Re: Everleigh Shopping Centre, Greenbank
Traffic Engineering Technical Memorandum – Response to Information Request

1.1 EDQ IR Item No.1 – Sight Distance Assessment

Attachment A

Sight Distance Assessment

Figure 2 – Location of Pylon Sign 2

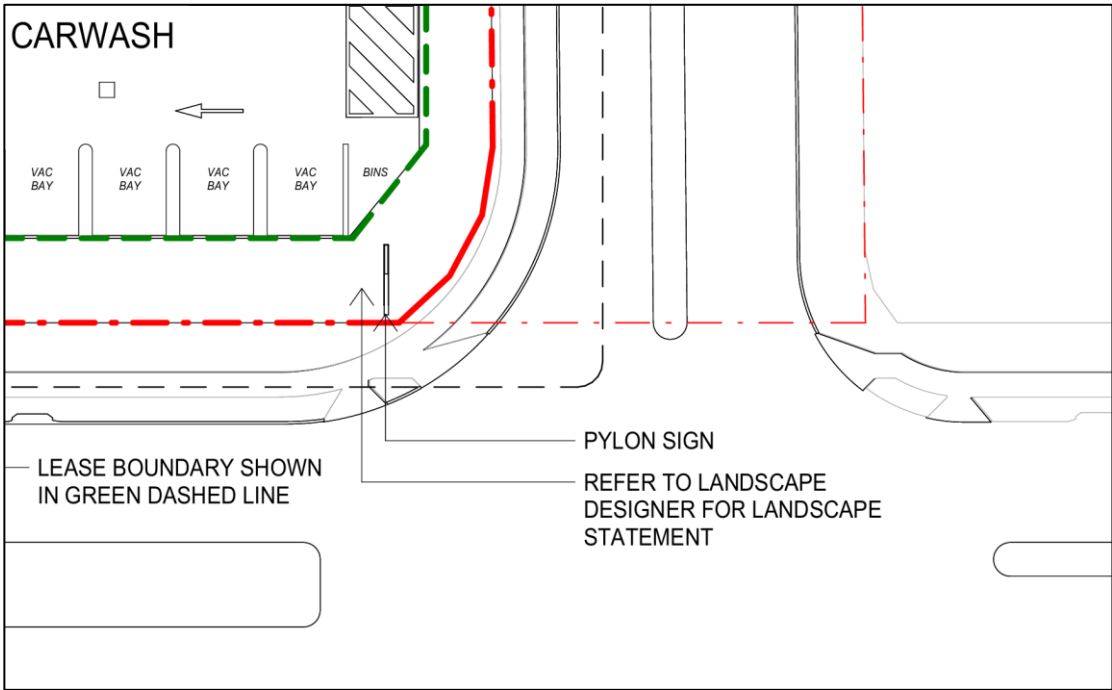
| 1. Demonstrate that vehicle sight lines are not obstructed at the Anderson Drive intersection as a result of Pylon Sign 2. |

Pylon Sign 2 is located at the north-western corner of the Anderson Drive / access road (new road) intersection. Accordingly, the critical sight-distance assessment is for a driver exiting the access road and looking west along Anderson Drive towards approaching eastbound vehicles. Consideration has also been given to the reciprocal sight line between an eastbound vehicle approaching from the west and a vehicle positioned at the access road (or less critically potentially "stalled" part way through a turn from the new road into Anderson Drive).

TTPlus has undertaken the sight distance assessment having regard to the location and dimensions of Pylon Sign 2. The location of Pylon Sign 2 is illustrated in Figure 2, while the overall structure and supporting 'column' dimensions are illustrated in Figure 3.
